MFN 08-086, Supplement 21

Subject: Response to Portion of NRC Request for Additional Information Letter No. 126 Related to ESBWR Design Certification Application RAI Numbers 14.3-174 and 14.3-263

**Response to Portion of NRC Request for Additional
Information Letter No. 126 Related to ESBWR
Design Certification Application**

RAI Numbers 14.3-174 and 14.3-263

Figure 7.8-1. Simplified DPS Block Diagram

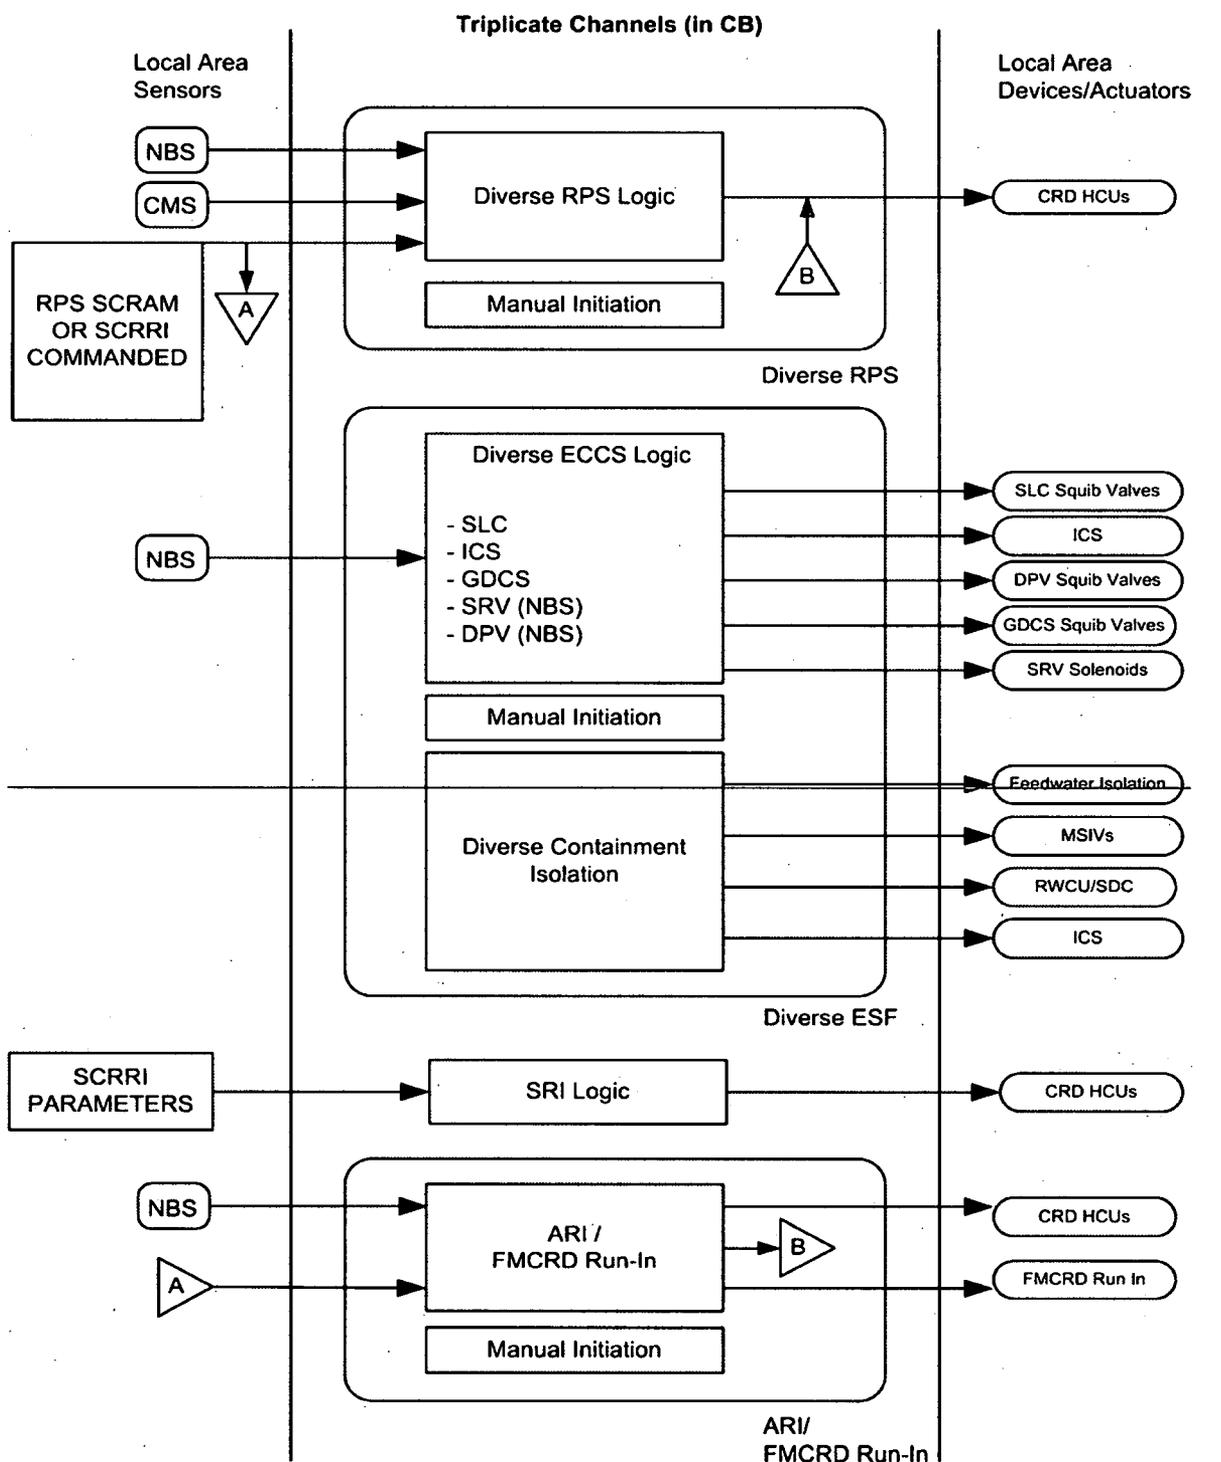
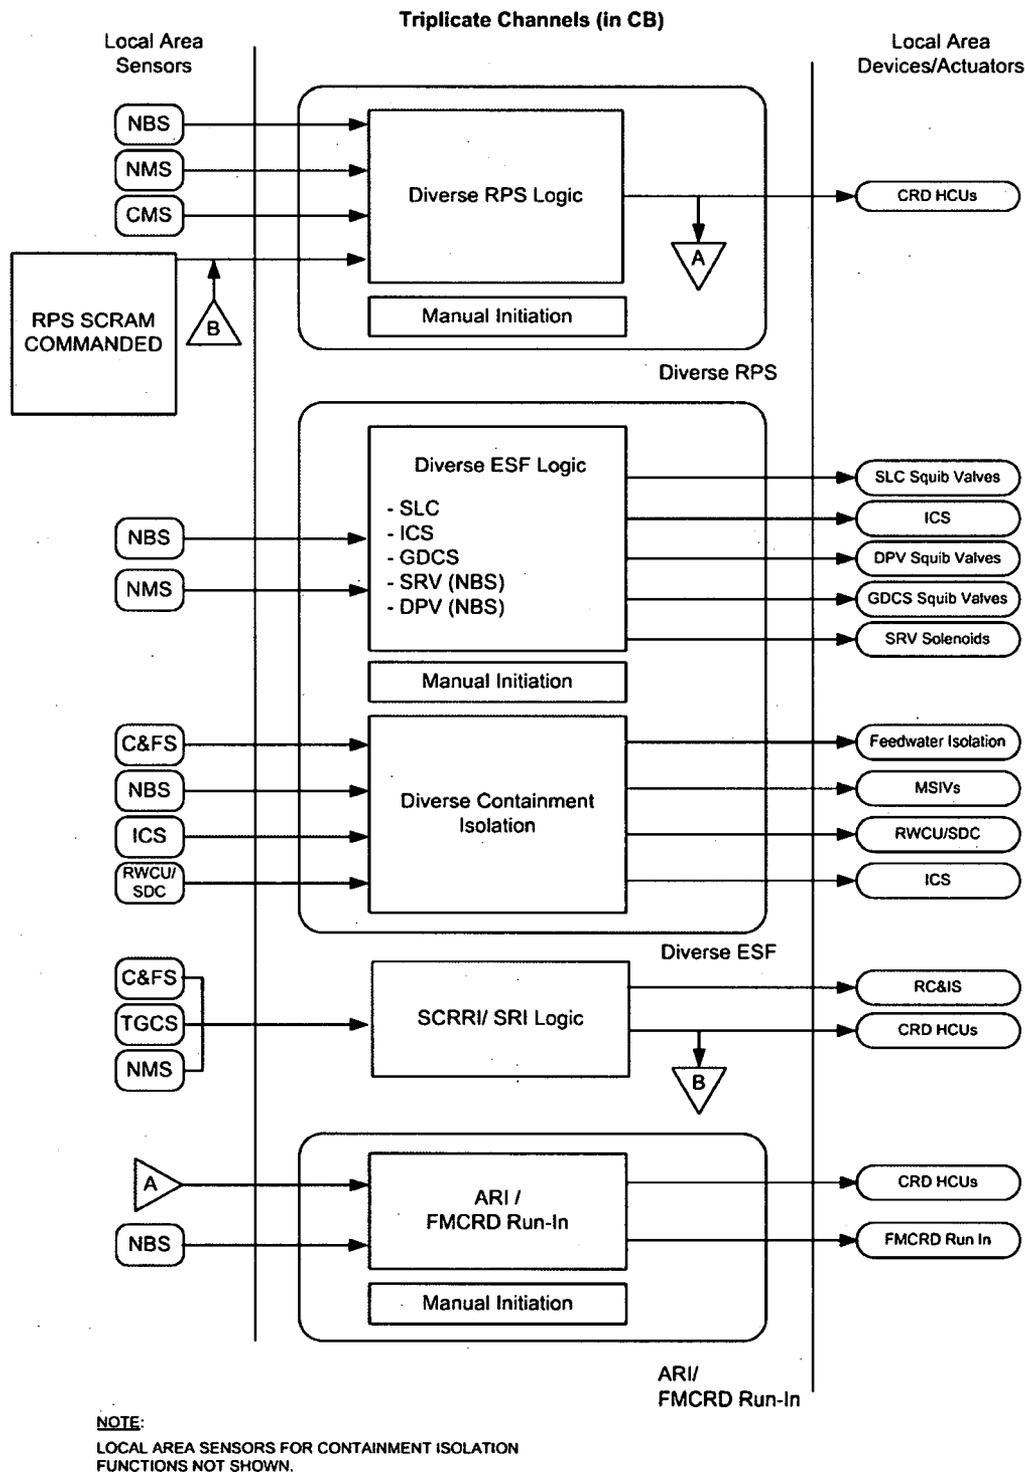
This figure 2.2.14-1, DICS Diagram is not in the DCD as referenced

DCD Tier 2, Rev. 4, Figure 7.8-1 was a duplicate of Tier 1, Rev. 3, Figure 2.2.14-1 and will be retained in Tier 2. Figure 7.8-1 will be updated for the next revision to reflect the DPS interfaces and boundaries that were not described by this figure in previous revisions. The updates to this figure reflect the system interfaces described in the text of Tier 2, Rev. 4, Section 7.8.

DCD Tier 2, Rev. 4, Figure 7.8-1, will be revised as shown in the attached markup.
